# UNITED STATES PATENT AND TRADEMARK OFFICE

APPLICATION NO.	FILING DATE	FIRST NAMED INVENTOR	ATTORNEY DOCKET NO.	CONFIRMATION NO.
10/713,665	11/17/2003	Milan J. Vavra		9840

<b>Office Action Summary</b>	<b>Application No.</b> 10/713,665	<b>Applicant(s)</b> VAVRA, MILAN J.	
	<b>Examiner</b> Robert P. Swiatek	<b>Art Unit</b> 3643

### **DETAILED ACTION**

FIG. 2

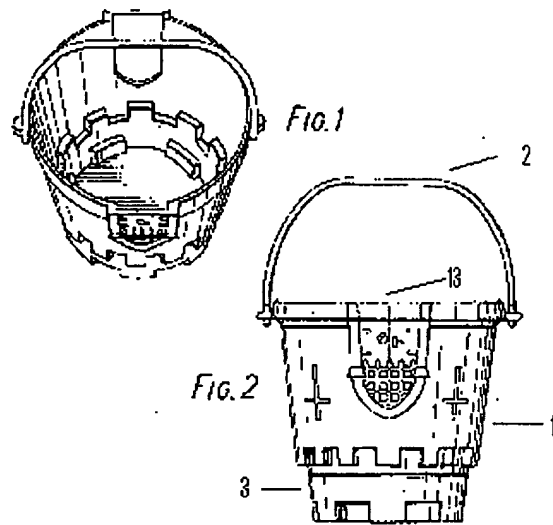
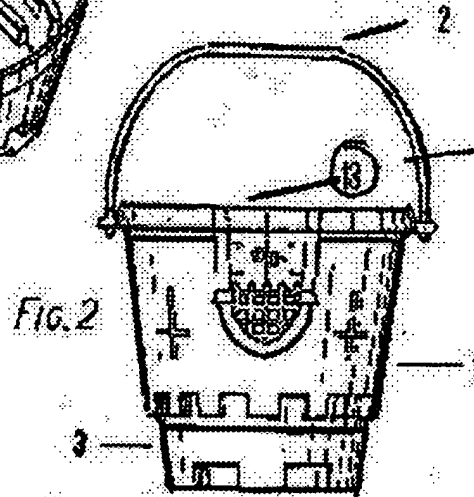
The attached sheet of drawings includes changes to Fig. 2. This sheet, which includes Fig. 1-2, replaces the original sheet including Fig. 1-2. In Figure 2, previously omitted element 13 has been added.

In amended Figure 2, the previously omitted element numeral 13 has been added.

Element 13  
added
